**GENERAL BULLETIN GB2023004
2023MY FORD E-BRAKE SIGNAL MODULE**

Subject:	2023MY Ford E-Brake Signal Module
Attn:	IMT Distributors
From:	IMT Sales
Date:	June 27, 2023
Affected Models:	All Dominator Body Models

2023MY SUPER DUTY F-250 – F-600 SEIC/PTO CONNECTOR LOCATION

2023 FORD SUPER DUTY IPU WITH OPTIONAL HEATER

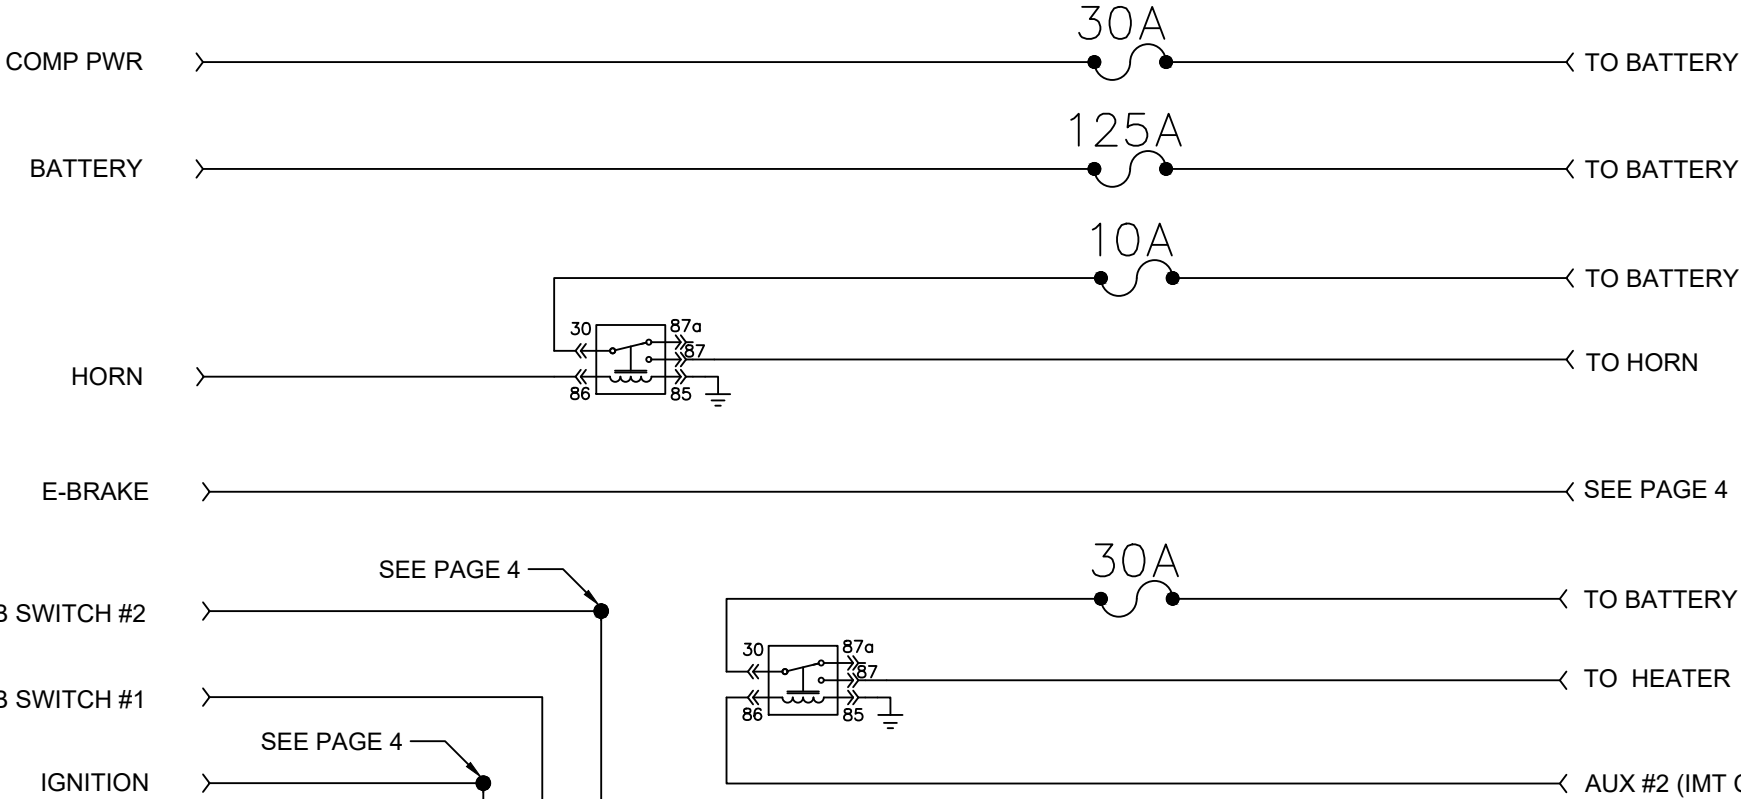
Ford Motor Co. has made IMT aware of various wiring changes to 2023MY F-250 - F-600 Super Duty chassis models. These changes resulted in the required installation of a decoder module to replicate the E-Brake signal for standard system operation.

Information regarding the 2023MY Ford Super Duty chassis wiring schematic, 99906878, is attached. All updated documentation is available on the Distributor Resource Center website.

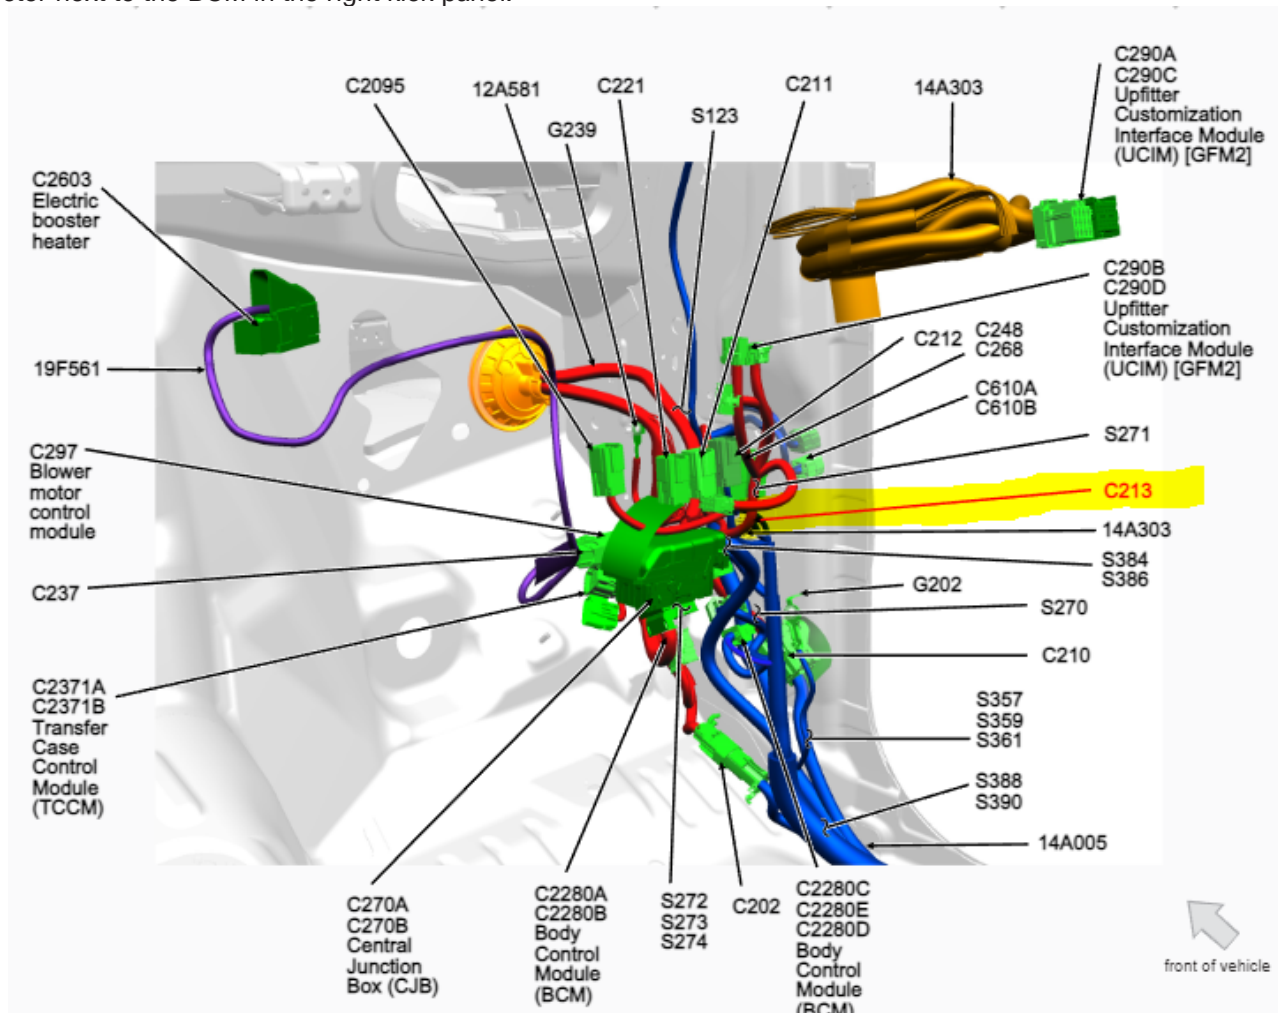
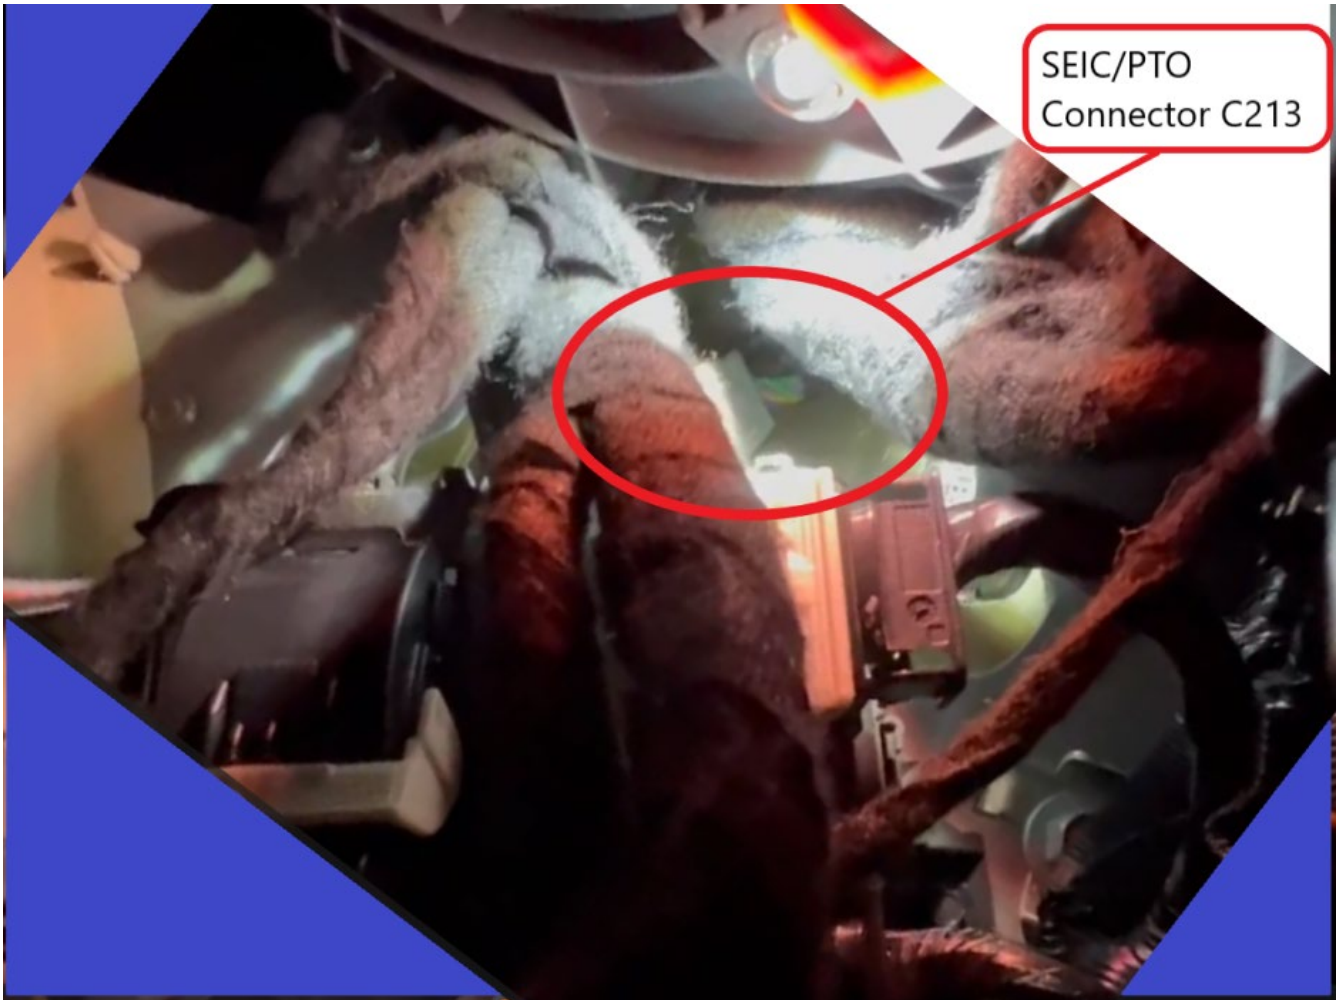
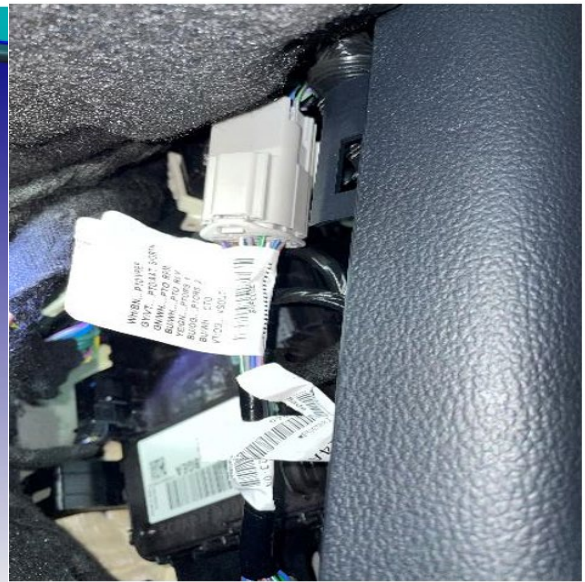
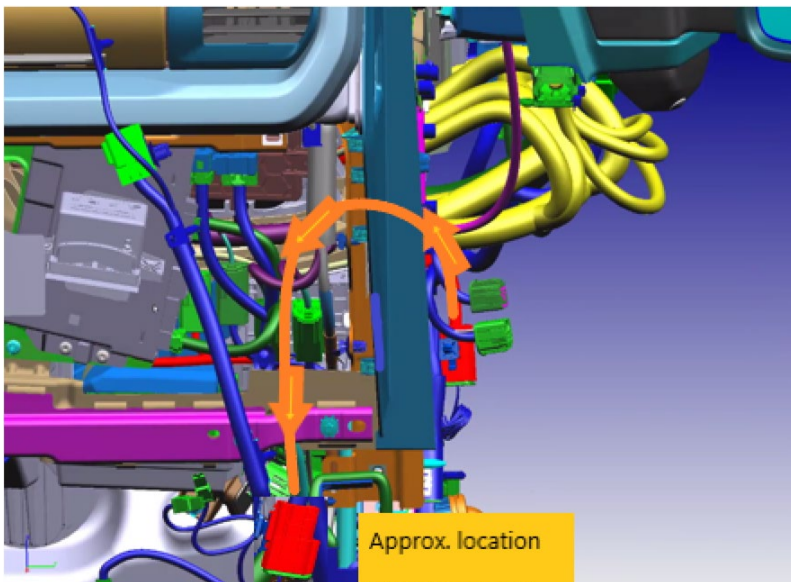
This Bulletin is intended to advise customers of the difficult to access C213 SEIC/PTO connector which is located on the right kick panel sheet metal. It is to help the customer locate the connector on the 2023MY Superduty and Super Duty Chassis Cab on the right passenger outboard kick panel. The customer will have to move the wiring harness out of the way to access Connector 213 as indicated in red. The bottom illustrations provide guidance to relocate the SEIC/PTO connector next to the BCM in the right kick panel.

Remove Connector (indicated in red) from portable hole. Disconnect pigtail connector (PC3T-14A303-C). Reroute connector over wire bundle and route downward toward BCM area. Secure connector with cable tie to wire bundle to reduce abrasion and rattle
